DEALER DAYS SERVICE NEWS FROM SPIETH

Service Topics

Service-kit "Ergojet Rio"

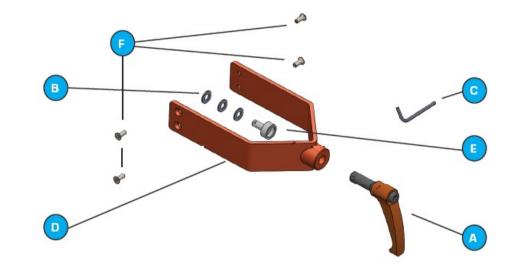
- Suitable for all "Ergojet Rio" vaulting tables
- The length of the thread of the lever has been modified
- M16x40 from M16x32

- A. 3182038 1x Clamping Lever M16x40
- B. 3129313 3x Thrust washer Ø20x10x1.5
- C. 3630020 1x Allen key 4 mm
- D. 4147970 1x Clamping band (M16)
- E. 4147976 1x Pressure pin

Floor anchor testing device

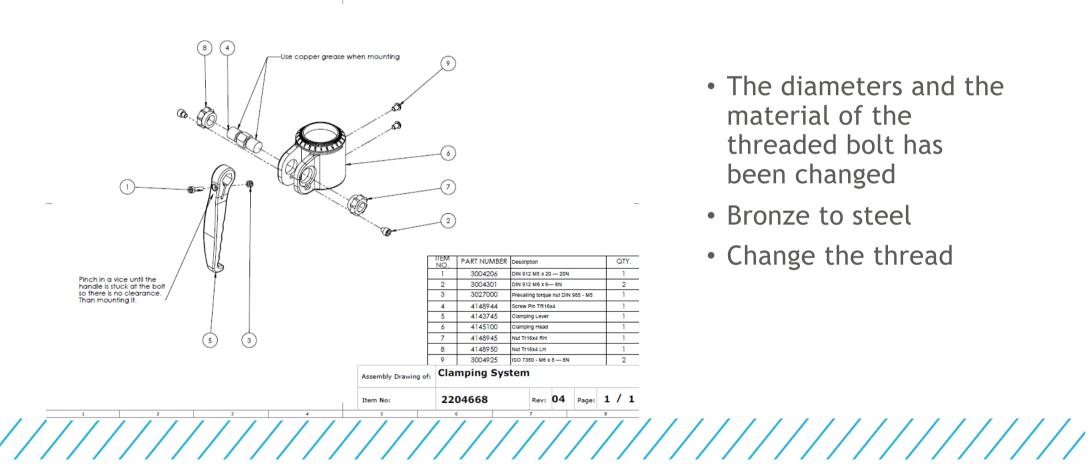
- Tension load: min. 8.000 N
- Testing is performed vertically using a dial gauge
- Test load: 10.000 N

- Required tension must hold 1 minute of test load
- Loss over 500 N : blocked and replaced

Rails for uneven bars

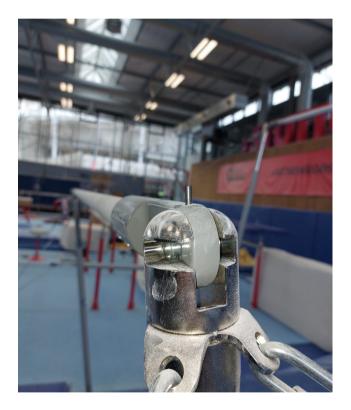
• Check the locking pins

- The position of the locking pins has been changed
- An additional safety factor has been added
- On the picture is the old version
